D2 Case No: A-21-1244827 Parcel ID(s): 18-249-01-124

Project Name: 3134 Smokestone Court

REQUEST: Variance from Chapter 27- 5.4.7.(D) – Walls, fences, and retaining walls of the DeKalb County Zoning Ordinance to increase of the maximum height for a proposed retaining wall from 4 feet to 8 feet.

Staff Recommendation: **“Approval with condition” based on the submitted site plan, received June 24, 2021, to increase the maximum height for a proposed retaining wall from 4 feet to 7 feet subject to the following condition:**

SHEET:
TREE PLAN
T-1 /
HARDSCAPE
PLAN
LS-2

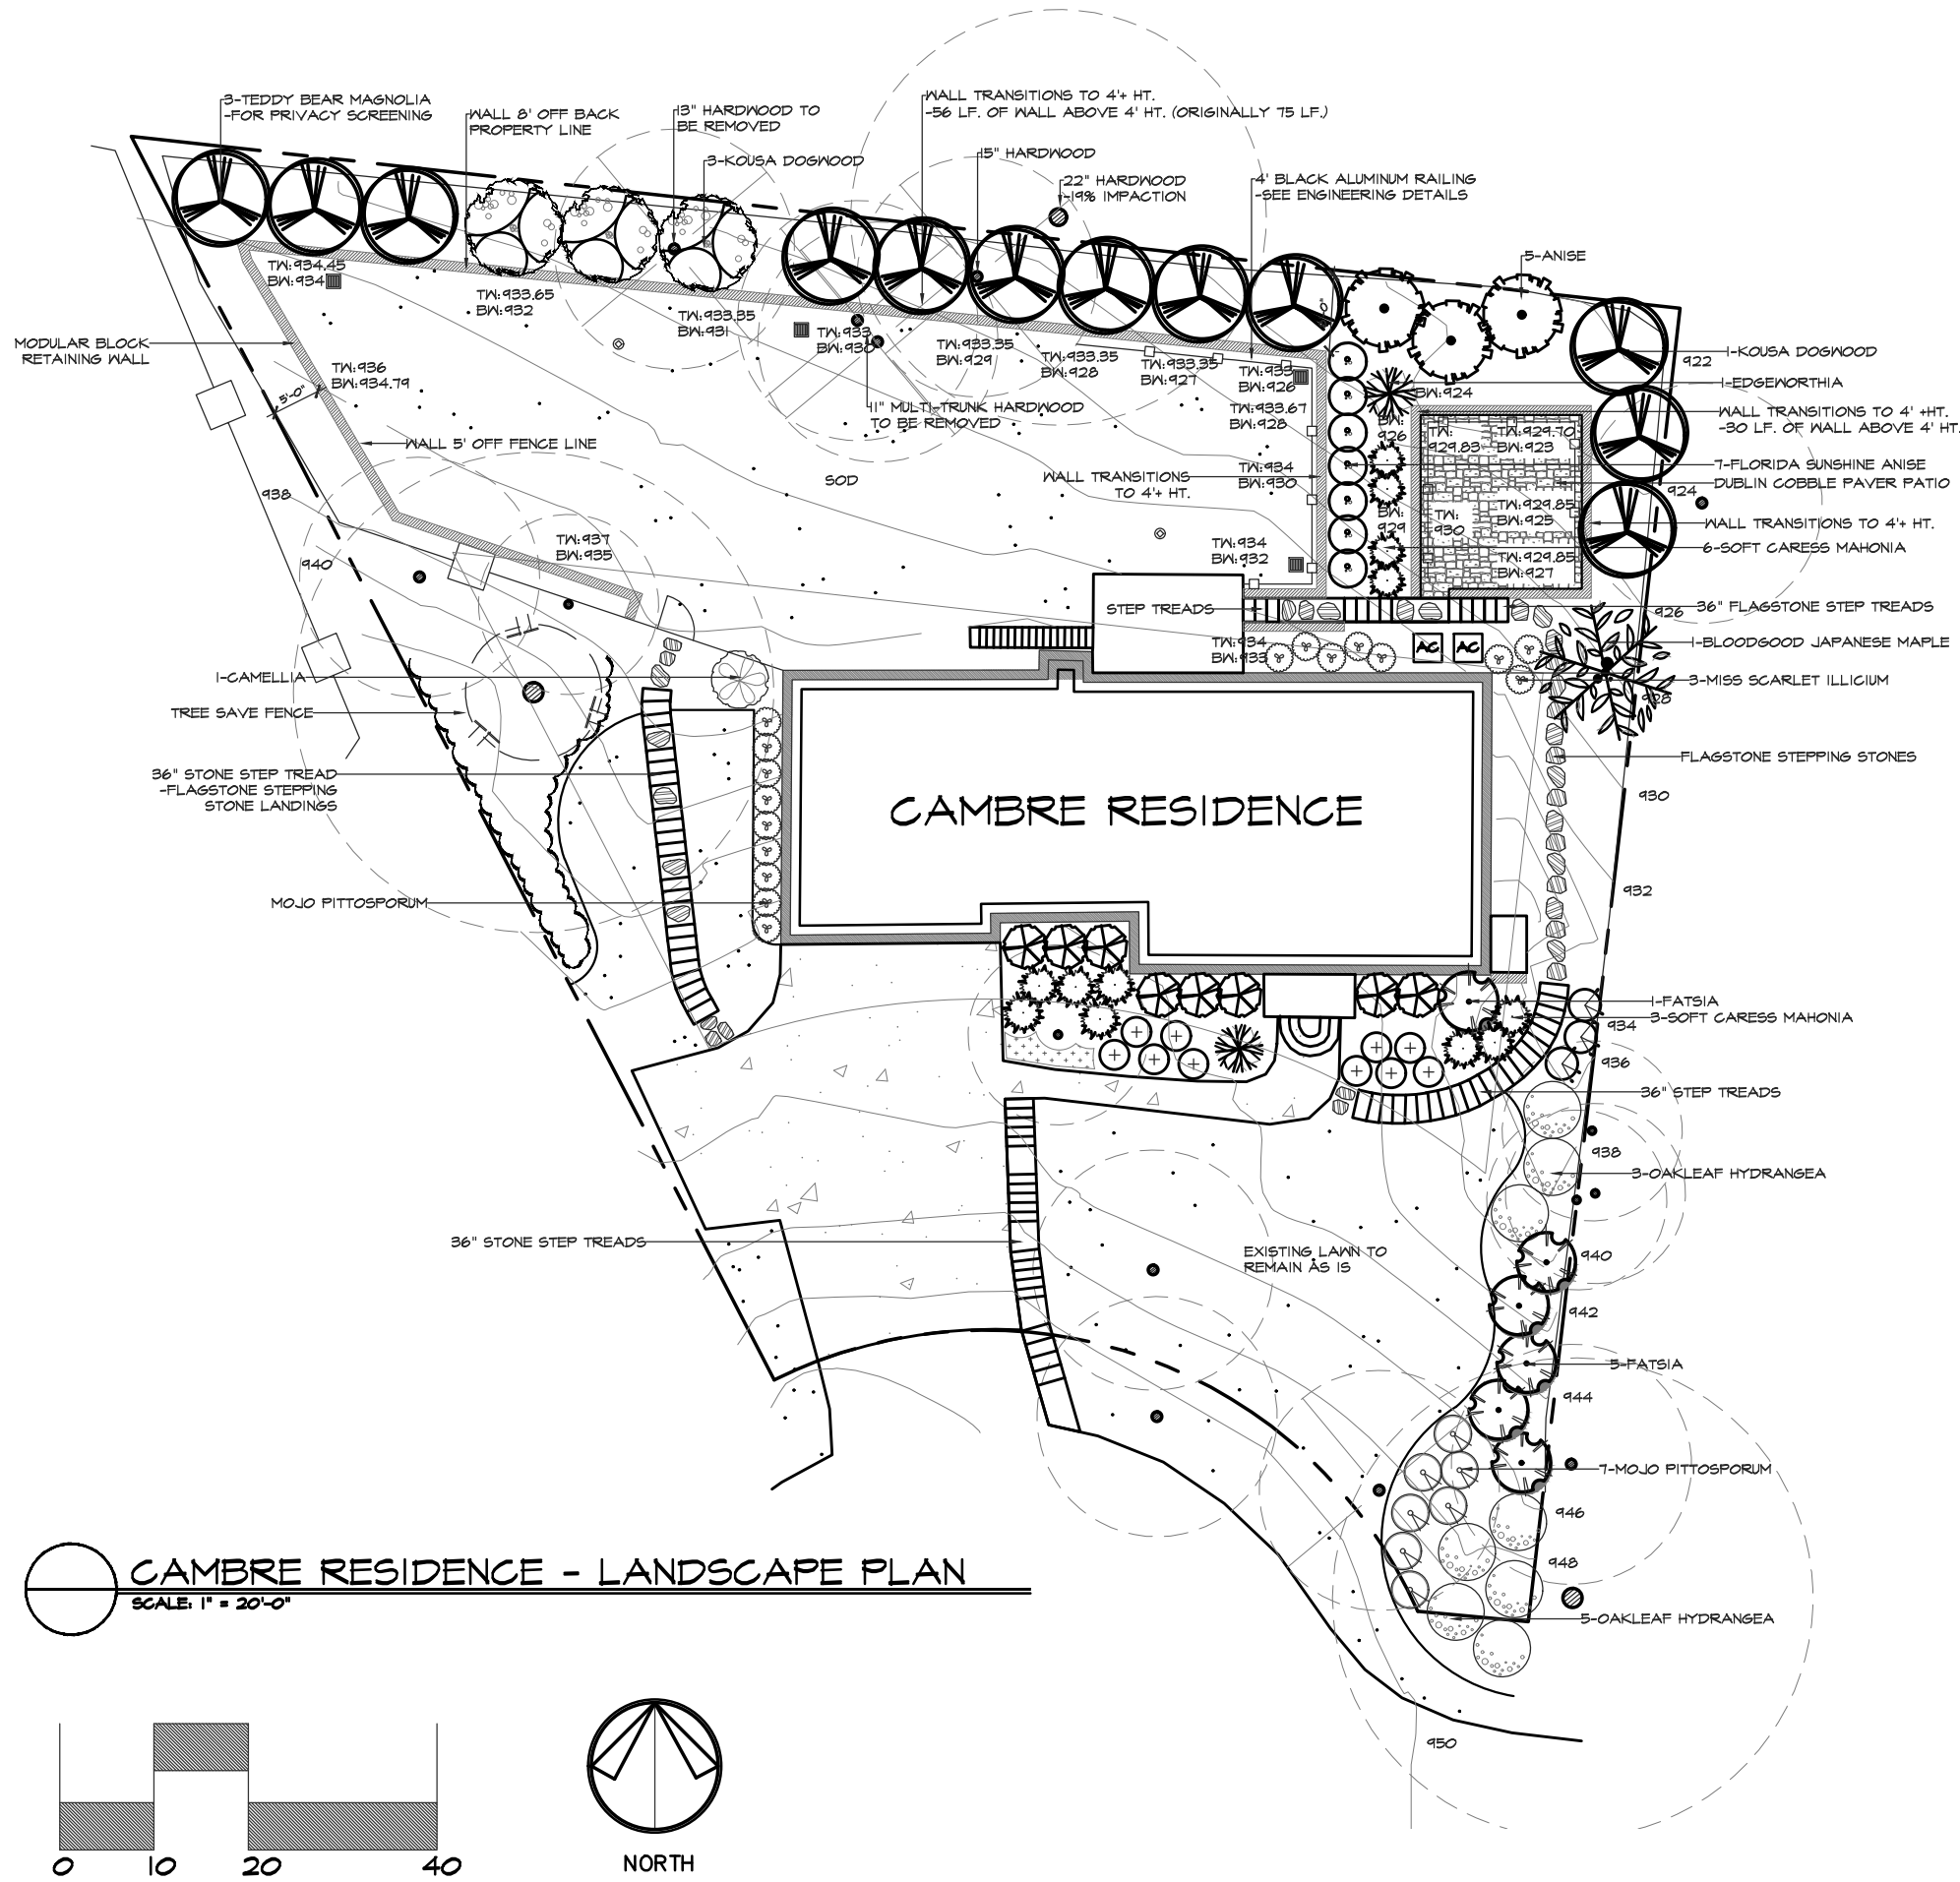
1. Moved & Reduced Wall to Reduce Impact:

- Upper retaining wall moved to 8' off the back property line and away from the adjoining property.
- Reduced proposed wall height to 7' from 8'
- Reduced the total linear footage of walls >4' to 56Lf from 75Lf.
- Eliminates a construction/maintenance easement.
- The impact on the neighbors 22" hardwood has been reduced to 19.1% impact (< 20% allowable limits)-see additional arborist letter
 - Arborist letter suggests but not required- conduct root pruning during wall excavation, and root injections on Cambre's property between the wall and fence to go above and beyond care and tree preservation during the proposed work.
 - Arborist letter suggests but not required – a fertilization treatment program to help stimulate root recovery though it is not necessary, it is to essentially go above and beyond future care and tree preservation after the work is complete.
- See new site plans.
